# NEW YORK STATE DEPARTMENT OF ENVIRONMENTAL CONSERVATION

Re: Remedial Action Work Plan  
Eldre Corporation  
Site No.: C828182  
Henrietta (T), Monroe (C)

The New York State Department of Environmental Conservation (Department) and New York State Department of Health (NYSDOH) (collectively known as the State) have completed a review of the Remedial Action Work Plan RAOC #3 (RAWP) dated August 2022, for the Eldre Corporation site (Site) located at 1500 Jefferson Road and 55 Hofstra Road, Town of Henrietta, New York. Based on the information presented in the RAWP, the RAWP is conditionally approved based on the clarifications, modifications, and conditions presented below.

[ 212721.01 ]  
[ FIGURE 4 ]

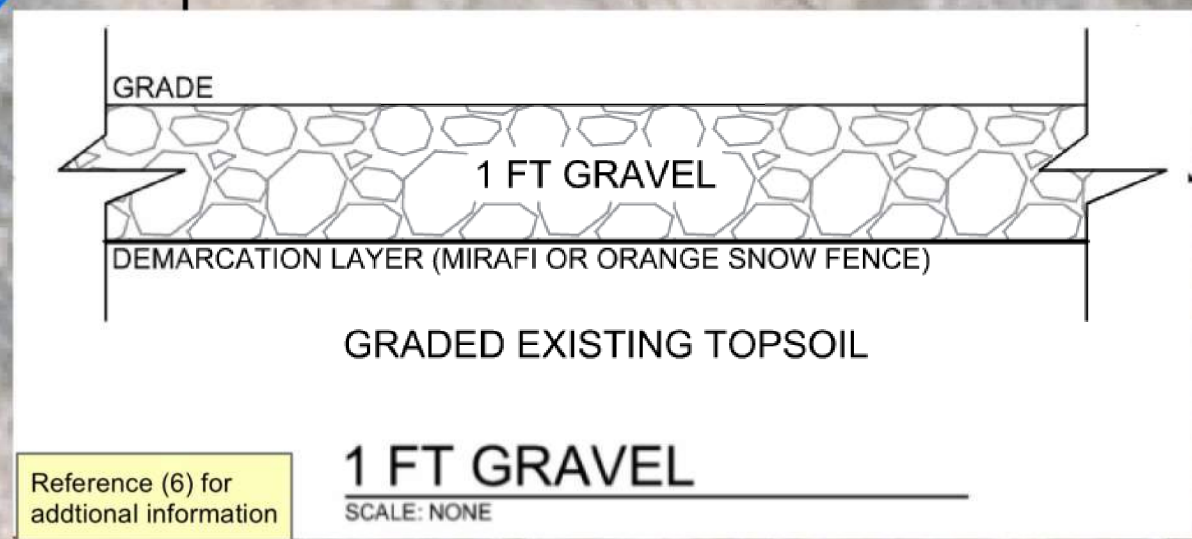
12. Section 5.1.2; 55 Hofstra Road Impacted Surface Soils; Page 16: The Department understands that the fence along the northern portion of the Site will be removed as shown on the attached figure and will be re-installed at the conclusion of the Site cover system installation. Temporary site control will be implemented during the remedy installation phase. The Site cover system will be extended to ensure that all impacted material will be addressed.

Fence to be removed.

Cover System will extend to the fence line

Cover System will stop 5-ft before the creek bank
